United States Patent and Trademark Office

APPLICATION NO.	FILING DATE	FIRST NAMED INVENTOR	ATTORNEY DOCKET NO.	CONFIRMATION NO.
10/568,720	02/16/2006	Heiko Bald	GP-307708	9584
200	7590 02/21/2007 OTORS CORPORATION	EXAMINER		
LEGAL STAFF			GLUCHOWSKI, KRISTINA R	
MAIL CODE 4 P O BOX 300	182-C23-B21	ART UNIT	PAPER NUMBER	
DETROIT, MI	48265-3000	3676		
SHORTENED STATUTORY PERIOD OF RESPONSE		MAIL DATE	DELIVERY MODE	
3 MO	NTHS	02/21/2007	PAPER

DETAILED ACTION

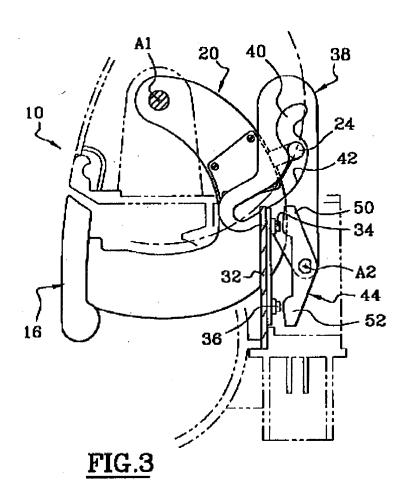
- 6. Claims 1-20 are rejected under 35 U.S.C. 102(b) as being anticipated by Suparschi (US 2001/0005082). Regarding claim 1, Suparschi shows a central locking system for vehicle doors comprising an electrical switch (34 and 44) for changing the central locking system to a locking or an unlocking state and an opening lever (16) which is pivotable disposed at an inside of a vehicle door (paragraph [0001]), for opening thereof wherein the switch is associated with the opening lever inside the door such that when the opening lever is pivoted out of an inoperative position into a first switched position, it effects a locking or an unlocking state of the central locking system and the locking or unlocking state is maintained until the opening lever is again pivoted into its switched position (see paragraphs [0061-62].

- 7. Regarding claim 2, "as best understood" when the opening lever is pivoted out of inoperative position into a mechanical opening position (see paragraph [0046]) the lever passes through a second switched position in which the switch generates a signal for changing the central locking system over to the unlocking state (see figure 4 for the unlocking position).
